WIRELESS STATION A 510

TRANSMITTER AND RECEIVER

REFERENCE:- Aust. Change in W.M. 13061.

PART A - SIDETONE

FIG. 1

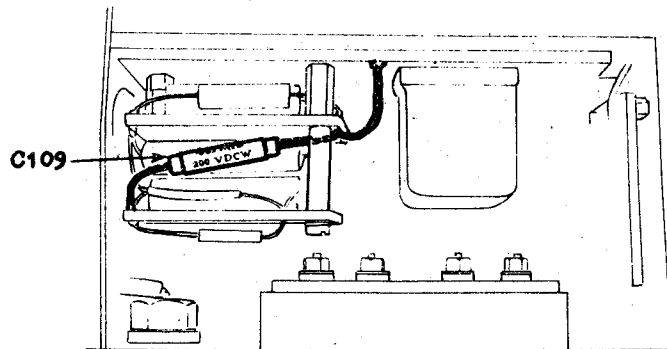
8. Change C 109 in the following manner; (see Fig. 1):-

- (a) Unsolder and remove C 109 (0.01uF).
- (b) Solder new C 109 (0.005uF) into position vacated by the 0.01uF, one end to earth point directly below the spacing pillar, and the other to the top tag diagonally opposite to the earth point.

FIG. 2

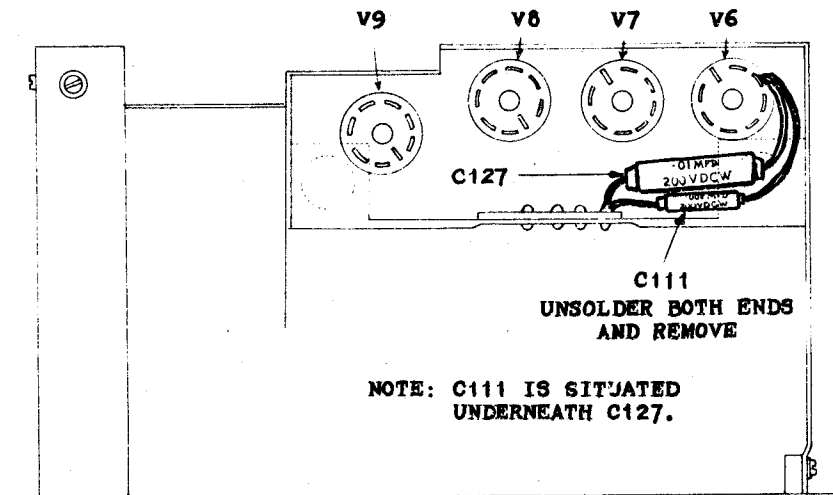
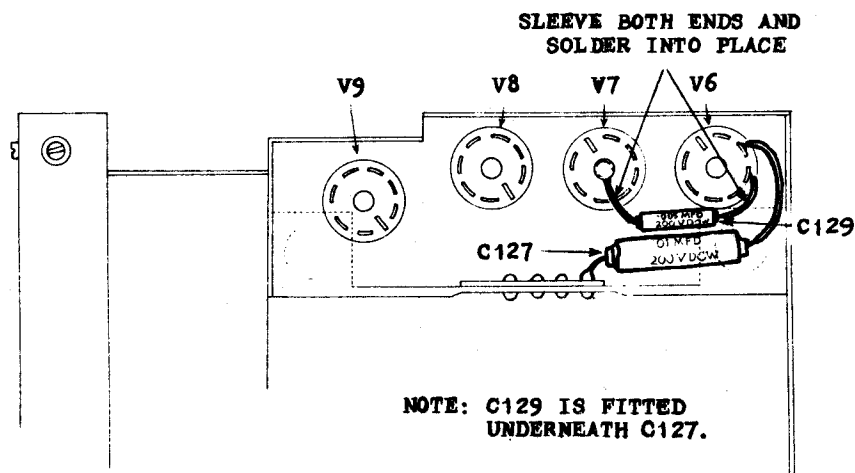
9. Remove C 111 and install C 129 in the following manner (see Fig. 2 and 3):-

- (a) Unsolder and remove C 111 (0.005uF) which is connected from pin 2 of V6 to terminal plate and lies beneath C 127 (0.01uF).
- (b) Place capacitor C 129 in space vacated by C 111 and cut leads to required length.
- (c) Sleeve the pigtails with yellow 1½MM PVC sleeving and solder one lead to pin 3 of V6 and one to the earthed spigot of V7.

FIG. 1

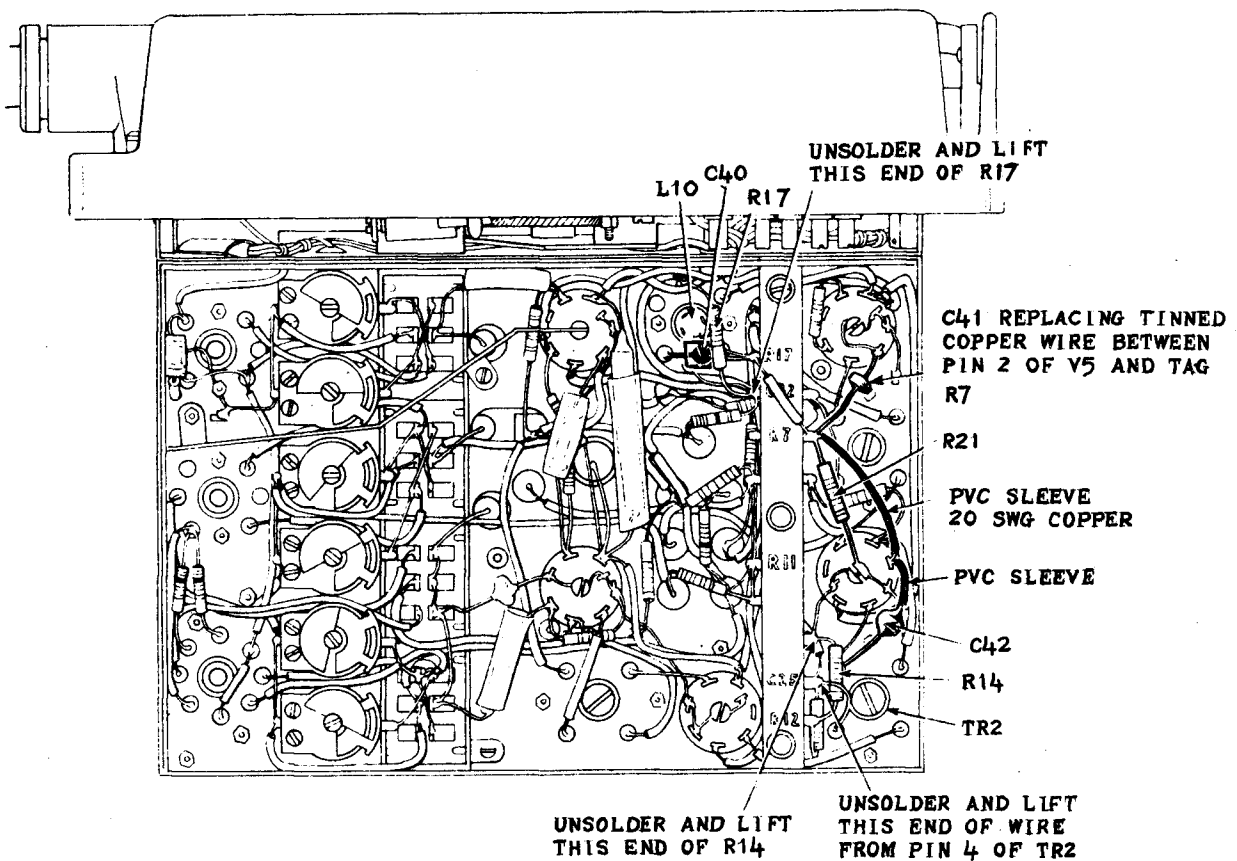
6. Remove receiver chassis from case and install the following as detailed (refer Fig. 1).
7. C40 -
  - (a) Unsolder and lift end of R17 (47,000 ohms  $\frac{1}{2}W$ ) connected to tag marked C32.
  - (b) Cover body of C40 with  $\frac{3}{8}$  in. of 10MM. PVC sleeving and solder into place, connecting between pin 1 (green spot) of L10 and the tag marked R17.
  - (c) Solder floating end of R17 back to tag marked C32.

8. C41 -
  - (a) Unsolder and remove wire lead connecting pin 2 of V5 to tag marked R7.
  - (b) Connect C41 between pin 2 of V5 and tag marked R7.
9. R21 -
  - (a) Connect R21 between tag marked R7 and centre spigot of V4.
10. C42 -
  - (a) Connect tag marked R7 to pin 4 of V4 using 20 SWG tinned copper wire covered with 1½ MM. yellow PVC sleeving.
  - (b) Unsolder and lift wire lead at tag marked C25 (this lead joins tag marked C25 and pin 4 of TR2).
  - (c) Unsolder and lift earth end of R14.
  - (d) Sleeve one end of C42 with yellow 1½ MM. PVC sleeving and connect this end to pin 4 of V4.
  - (e) Connect other end of C42 to pin 1 (red spot) of TR2.
  - (f) Replace R14 and lead wire which were removed as in (b) and (c) above.
11. Strike out the number "2" on the receiver modification plate.
12. Replace unit in case and check netting and general function of receiver.
